Renault Espace (JE)

Temporary failure of the air conditioning / heating fan

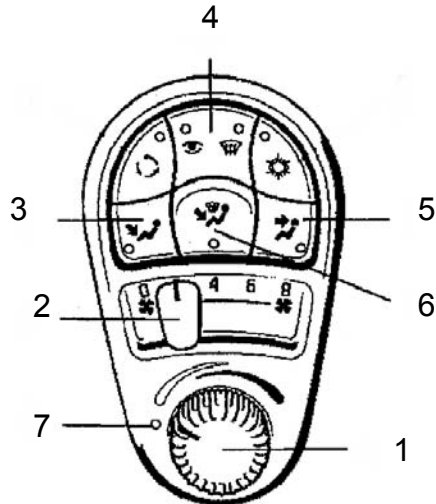
If in the case of the above-mentioned vehicles with the fabrication numbers listed below the air conditioning/heating fan should fail temporarily, a faulty cable connection on the relay carrier could be the cause. The electrical relay connection in the fuse box (engine compartment) is modified as follows using a repair kit supplied by the vehicle manufacturer:

- Disconnect the battery and remove if necessary
- Take the cover off the fuse box
- Remove the relay (234) with holder
- Remove the relay bracket and shorten the cable to a length of 150 mm
- Install the repair kit and connect to the vehicle cable strand
- Put back together in reverse order
- If necessary enter the radio code and, if LEDs 3+5+6 light up continually (see drawing), initialise the heating fan

Carry out initialisation as follows, with the ignition switched off (see drawing):

- Set the temperature control (1) to "cold air" by turning it anti-clockwise (as far as it will go)
- Set the speed control (2) to "O" and press buttons 4+6 simultaneously, and, keeping them pressed, switch on the ignition
- As soon as warning lamp 7 flashes, release the buttons
- The setting has been successful if the warning lamps of buttons 5+7 are lit continually
